# UNITED STATES PATENT AND TRADEMARK OFFICE

APPLICATION NO.	FILING DATE	FIRST NAMED INVENTOR	ATTORNEY DOCKET NO.	CONFIRMATION NO.
10/670,806	09/25/2003	Malte Blomeyer	2001P04429WOUS	7583
7590	10/04/2005		EXAMINER	
SIEMENS CORPORATION INTELLECTUAL PROPERTY DEPT. 170 WOOD AVENUE SOUTH ISELIN, NJ 08830			KIM, TAE JUN	
			ART UNIT	PAPER NUMBER
			3746

<b>Office Action Summary</b>	<b>Application No.</b>	<b>Applicant(s)</b>	
	10/670,806	BLOMEYER, MALTE	
	<b>Examiner</b>	<b>Art Unit</b>	
	Ted Kim	3746

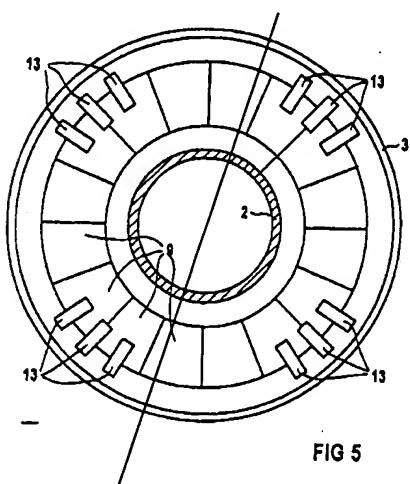
6. Claims 1-3, 7-21 are rejected under 35 U.S.C. 103(a) as being unpatentable over Becker (6,152,724) in view of Becker (5,451,160). Becker '724 teaches the blocking members 13 in the inlet region but not in the upstreammost portion, i.e. at the outer periphery situated at the air inlet. Becker '160 shows a blocking projection at the upstreammost portion, at the outer periphery, situated at the air inlet. It would have been obvious to one of ordinary skill in the art to place the blocking projections at the upstreammost portion at the outer periphery of the air inlet, as a well known location for protrusions. It is not clear whether Becker '724 will have the recirculation zone toward the outer periphery. However, Becker '160 also teach an outlet structure of the burner, which appears identical to that disclosed in the present application, and a recirculation zone at the outer periphery of the outlet is inherently present as the outlet configuration of

Becker '160 appears identical to that of the disclosed invention and it is well known in the art that the sudden expansion of the flow at the outlet will inherently cause recirculation zones. It would have been obvious to one of ordinary skill in the art to employ the outlet configuration of the Becker '160, as a well known alternative outlet configuration contemplated for the burner type of Becker '724, where such a configuration will inherently produce the claimed recirculation. Becker appears to illustrate the claimed blocking area ratios of the blocking members. In order to obviate any doubt, it would have been obvious to one of ordinary skill in the art to employ the claimed ratios, as an obvious matter of finding the workable ranges in the art. As for distributing the blocking members asymmetrically, Becker '724 does allow for non-circular symmetry (see Fig. 5) and depending on the axis on which the axis is taken will also appear asymmetric. Alternately, Becker also would teach one of ordinary skill to allow for some variation from symmetry to accommodate burner inlet tolerances and deviations from the idealized case.

asymmetric about this line
